RE: Addendum #2 to the Issued for Bid Package

This Addendum forms a part of the Contract Documents and modifies the original Issued for Bid package dated February 27th, 2023.

PRE-BID QUESTIONS AND ANSWERS

PROJECT: **RSU 56 BUS GARAGE**
DIXFIELD, ME
FOR:

C2.1

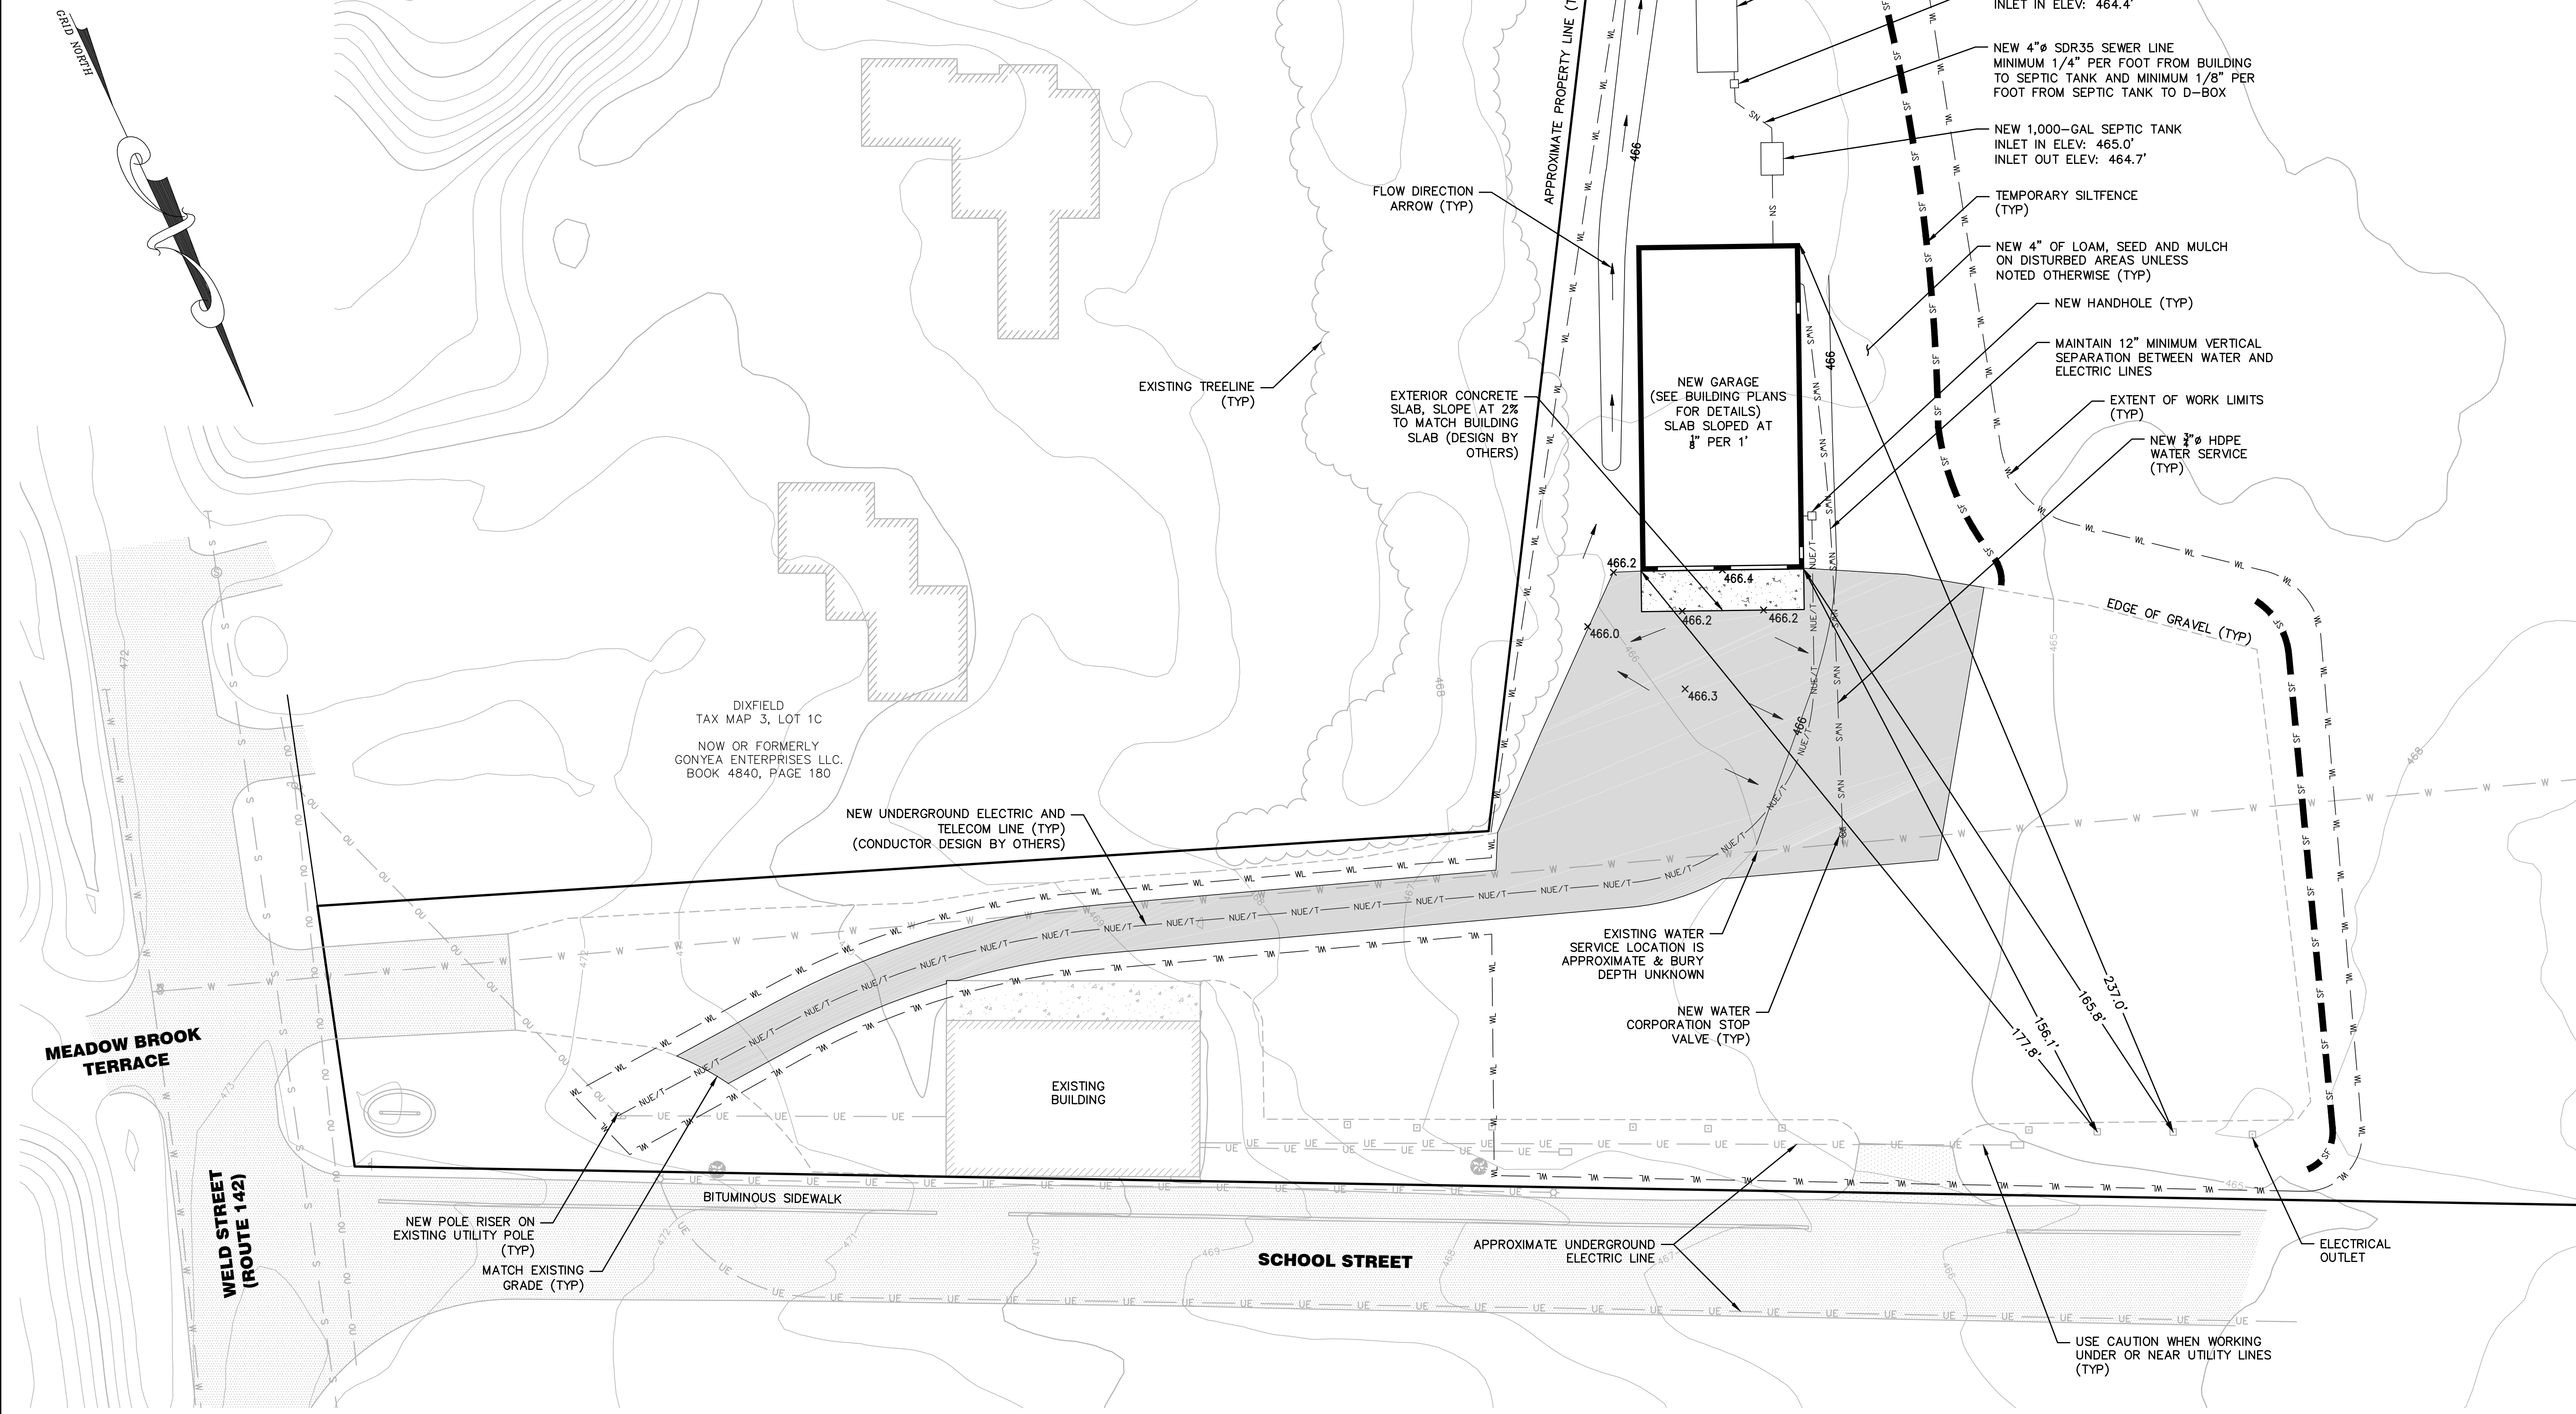
Q: 26000 – Does the Owner have any specific IT requirements, electrical requirements, tel/data jacks, etc.?

A: New fiber optic line to be installed in conduit from utility pole to building per revised drawing C2.1. Service Provider is Spectrum. Provide and install a Data switch and access point at the mezzanine (final location TBD). Install (2) Cat. 6 Cables from the mezzanine to the office for the Phone/Data connection.

SUBMISSION 6: 2023-03-13 TLB
ISSUED FOR BID. UPDATED
UNDERGROUND ELECTRIC LINE TO
INCLUDE TELECOM.

A1 WALL SECTION AT MEZZANINE

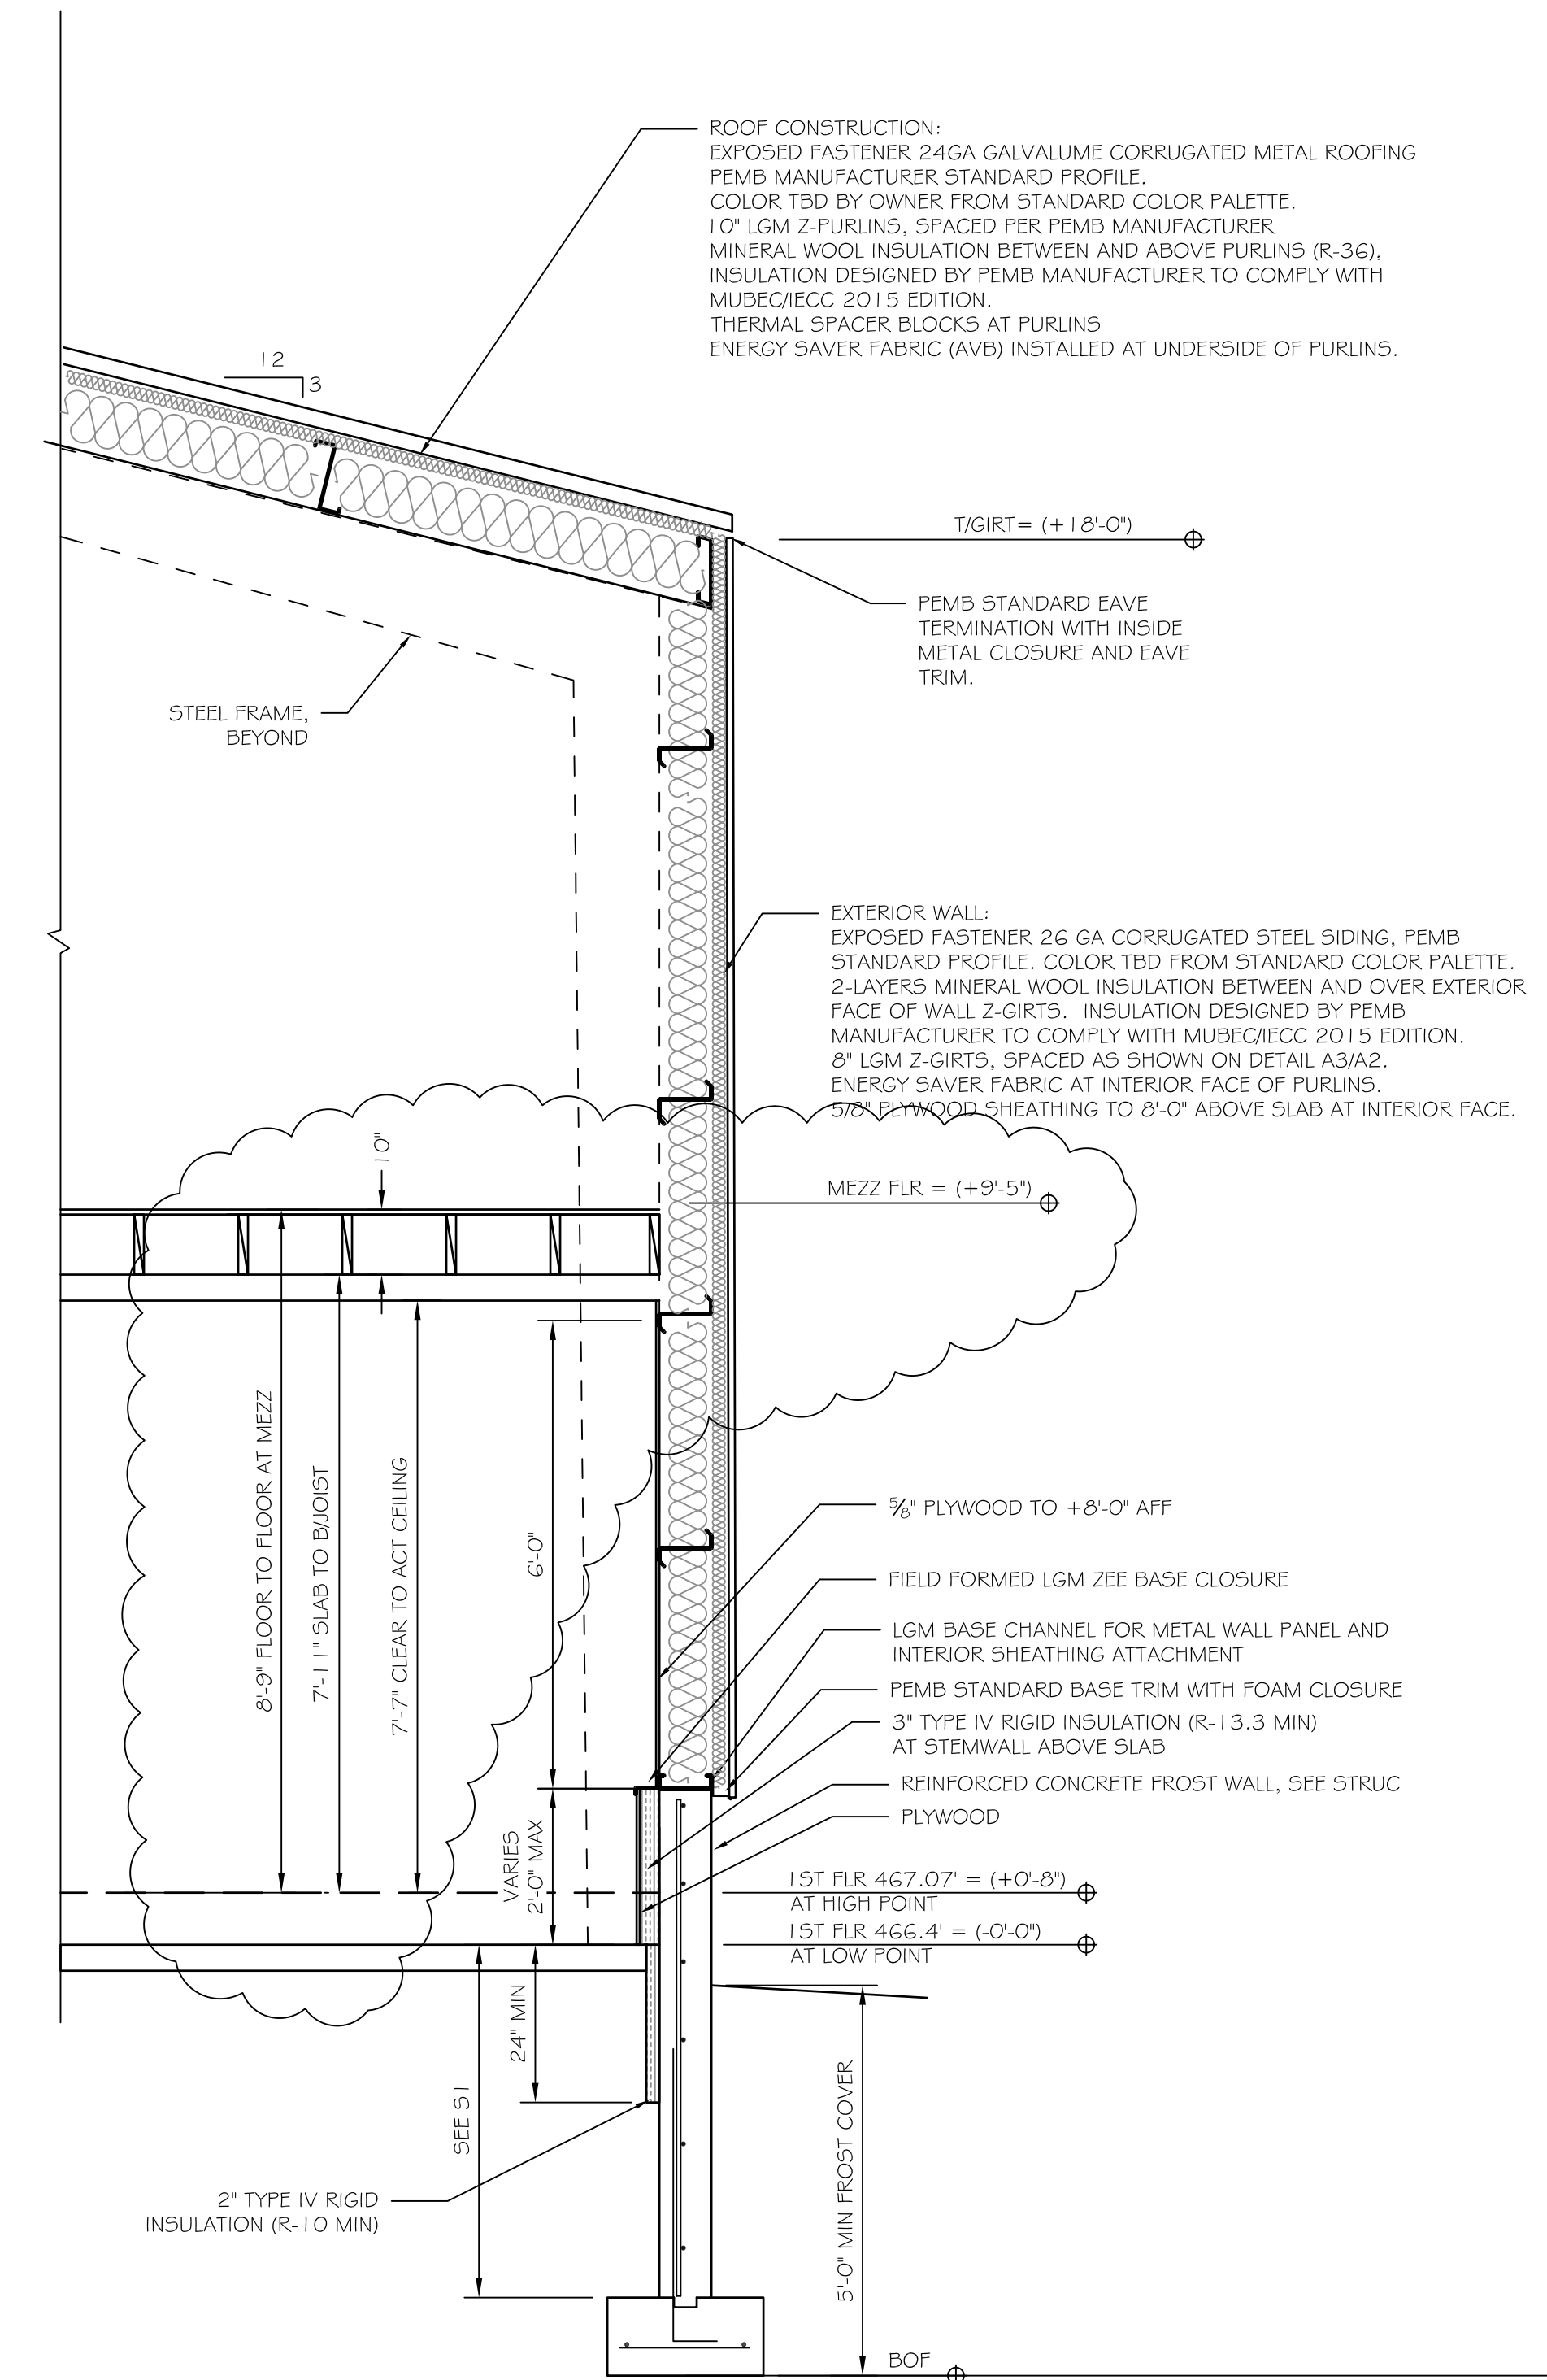
Q: A1/A2 – Bottom of joist to top of Mezz plywood depicts 8”. A1/S2 calls out for 2x10 joists. Which is correct? Also, what lumber will be used?

A: Floor will be framed with 2X10's. Refer to S3 for lumber spec. See revised section A1/A2 (attached).
